Access Compliance Report Public Rights-of-Way (Curb Ramps)

Main Street: OAK_KNOLL_DR Cross Street: OAK_KNOLL_DR Location: SW

ADA ID: RPRK211221122157 Ramp Type: Type 1 - Perpendicular Diagonal Initial Pass/Fail: Fail Overall Compliance: No Severity Score: 16

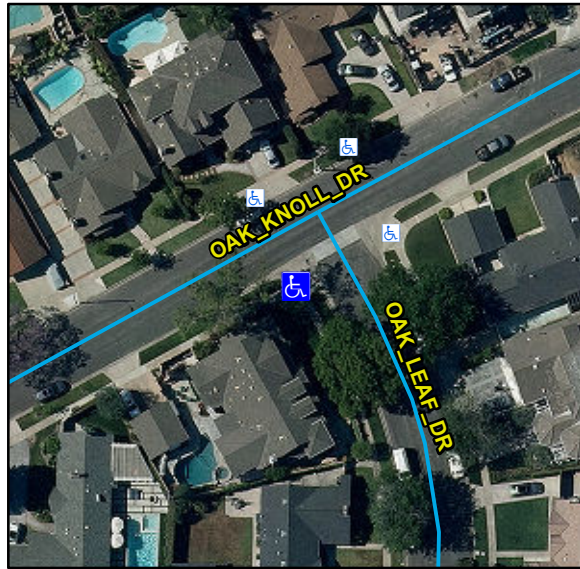
Compliance	Description	Data	Compliance	Description	Data
N/A	Ramp Length (in)	84	N/A	Flare Type LT	
Yes	Ramp Width (in)	54			N/A
No	Ramp Run Slope (%)	8.4	N/A	Flare Slope LT (%)	N/A
Yes	Ramp Cross Slope (%)	1.3	N/A	Flare Traversable LT	N/A
N/A	Landing Present	N/A	N/A	Flare Type RT	
N/A	Landing Length (in)	N/A			N/A
N/A	Landing Width (in)	N/A	N/A	Flare Slope RT (%)	N/A
N/A	Landing Run Slope (%)	N/A	N/A	Flare Traversable RT	N/A
N/A	Landing Cross Slope (%)	N/A	N/A	DWS Provided	N/A
N/A	Landing Movement Obstructed?	N/A	N/A	DWS Contrast	N/A
	Landing Movement Type	N/A	N/A	DWS Length (in)	N/A
N/A	Landing Shared	N/A	N/A	DWS Full Width	N/A
N/A	Clear Space	Yes	N/A	DWS Offset Left (in)	N/A
N/A	Clear Space To Crosswalk (in)	N/A	N/A	DWS Offset Right (in)	N/A
N/A	Marked Crosswalk 1	No	N/A	Marked Crosswalk 2	No
	Crossing 1 Direction	E		Crossing 2 Direction	N
	Marked Crosswalk 1 Width (in)	N/A		Marked Crosswalk 2 Width (in)	N/A

N/A	Ramp Inside Crosswalk 1	N/A	Yes	Ramp Inside Crosswalk 2	N/A
	Crossing 1 Slope (%)	3.2		Crossing 2 Slope (%)	7.1
	Crossing 1 Cross Slope (%)	1.2		Crossing 2 Cross Slope (%)	0.1
N/A	Gutter Ponding	N/A	N/A	Curb Slope	1.1
Yes	Gutter Lip Height (in)	0		Road Run Slope (%)	0.5
N/A	Gutter Run Slope (%)	N/A		Road Cross Slope (%)	0.1
N/A	Gutter Cross Slope (%)	N/A			
Yes	Overall Surface Condition: Acceptable		No	Perp Joint Present	No
	Cross Gutter Present?	Yes		Spandrel Present?	Yes
	Replace Cross Gutter?	No		Replace Spandrel?	No

Remove & Replace Curb Ramp With Two New Directional Ramps or Equivalent.
